N554 UPS2721-1BNAS1

# TECHNICAL BULLETIN

Update Prior to Sale: Air Conditioning (A/C) Compressor Bolts Incorrectly Torqued

MODEL:	MODEL YEAR:	VIN:
Range Rover Velar (LY)	2021	297299-302515

7. ■

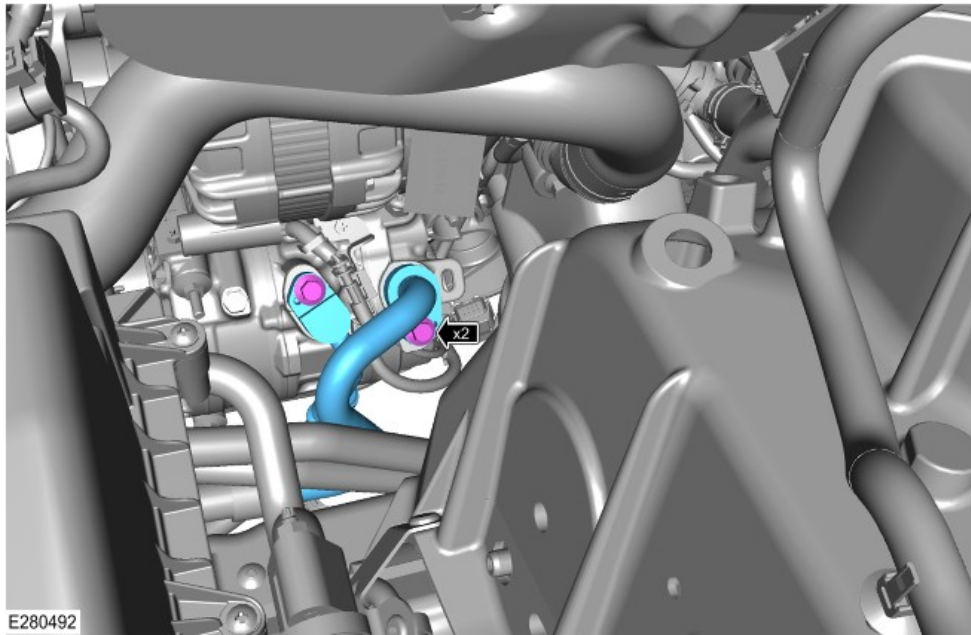
An issue has been identified on certain Land Rover vehicles within the listed Affected Vehicle Range where the torque setting for the Air Conditioning (A/C) pipes-to-compressor joints was incorrectly set at 9 Nm and not the required torque value of 19 Nm.

With the coolant expansion tank repositioned for access, tighten the A/C pipe bolts.

- Torque: 19 Nm
